The Cobourg Dragon Boat and Canoe Clubs wholeheartedly supports the Town of Cobourg in the installation of an Accessible Water Sport Dock at the Cobourg Marina. Since 2012, the CDBCC has made several presentations to Town Council and the Accessibility Committee. These presentations have always been met with support, however funding has never been put into budgets that would allow the projects to go forward.

I have read the proposed dock that is being purchased from Canada Docks, read the ACA Standards "CSA B651-12 Accessible Design for the Built Environment" document, and did research into what accessible docks should look like. I have several concerns about the dock being purchased by the Town and in fact do not believe it is an "Accessible Dock". I am not an authority on ACA Standards, but this are my interpretations of the document.

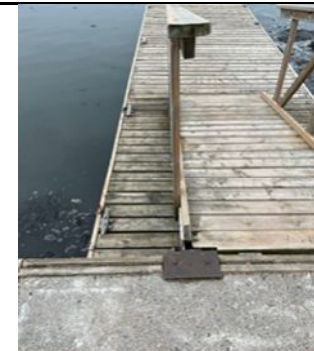
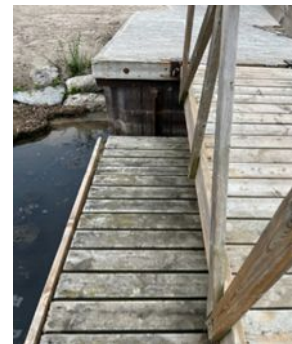
Having used the dock ramp numerous times over the past 20 years, I know that it can be very steep in low water times, very slippery after rain, and if more than 4 people are on it at the ends then it begins to sink. This will make it an unstable surface for wheelchairs. According to ACA Standards the **"Slope ratio should be between 1:20 and 1:15"**, and that ramps **"be at least 1200 mm wide."** The vertical rise of the dock to the cement walkway this fall is 28". That would mean the ramp would be between 420" - 540" long (35-46'). This would be longer than the present dock, which is 28' long. Further, the present ramp is not wide enough as it is only 42' (1066 mm). Is the cost of building a new 35' ramp in the budget?

The present walking space on either side of the ramp when it is on the dock is between 24-30". With a wider ramp, this space would be even more reduced, making the entire dock under the ramp dangerous to use, if it could be used at all. This dock would then no longer be useful for boaters using the boat launch.
